PROJECT LAYOUT SHEET #69

PROJECT NAME: STOCKBRIDGE-BETHEL
PROJECT NUMBER: STP 2910(1)
FILE NAME: z10b214_bdr_nul_69.dgn
PROJECT LEADER: D.E.G.
DESIGNED BY: L.M.B.
IPARM FILE: z10b214169.i
PLOT DATE: 3/17/2014
DRAWN BY: W.G.P.
CHECKED BY: J.P.S.
SHEET 102 OF 397

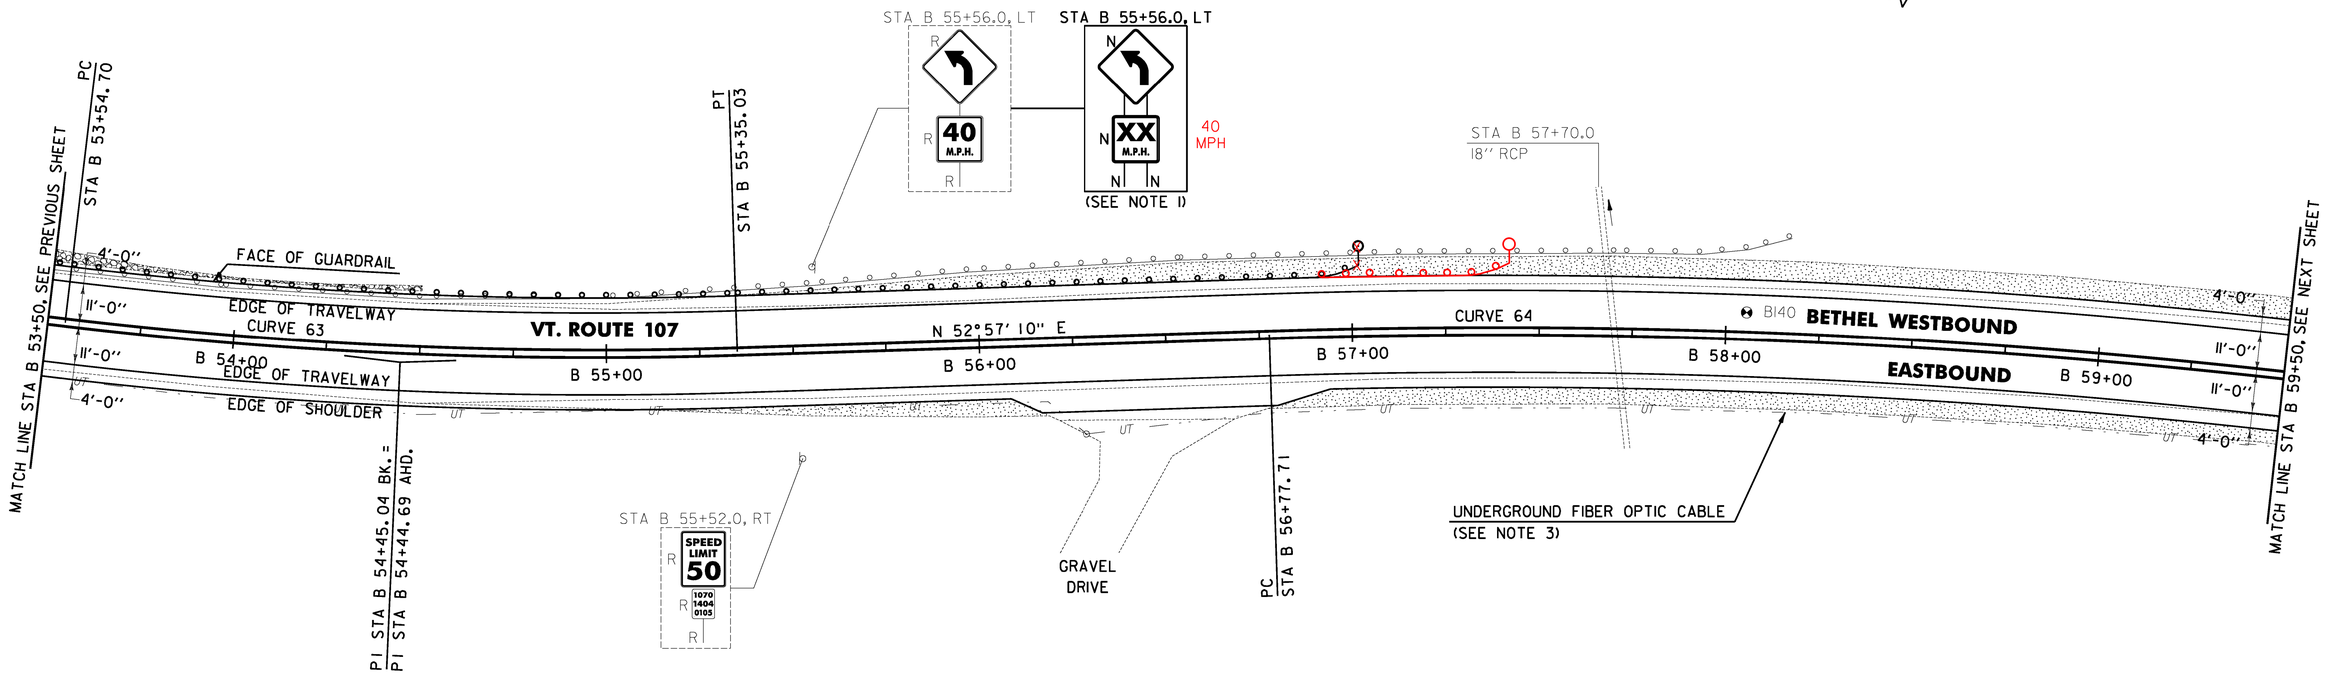
~~646.402 DURABLE 4 INCH WHITE LINE, THERMOPLASTIC OR~~
646.404 DURABLE 4 INCH WHITE LINE, POLYUREA
(ALL LINES WILL INCLUDE EDGE LINE BREAKS AND RADIUS FOR TOWN HIGHWAYS)
BETHEL:
STA B 53+50.00 - STA B 59+50.00 LT & RT

613.10 STONE FILL, TYPE I
BETHEL:
STA B 53+50.0 - STA B ~~54+50.0~~ 54+57.0 LT (6.1 CY)

621.205 STEEL BEAM GUARDRAIL, GALVANIZED W/8 FEET POSTS
BETHEL:
STA B 53+50.0 - STA B ~~57+02.0~~ 54+41.0 LT (352.0 LF)

651.40 GRUBBING MATERIAL (6")
BETHEL:
STA B 53+50.0 - STA B ~~54+50.0~~ 54+57.0 LT (14.7 SY)

~~653.20 TEMPORARY EROSION MATTING~~
~~BETHEL:~~
~~STA B 53+50.0 - STA B 54+50.0 LT (14.7 SY)~~
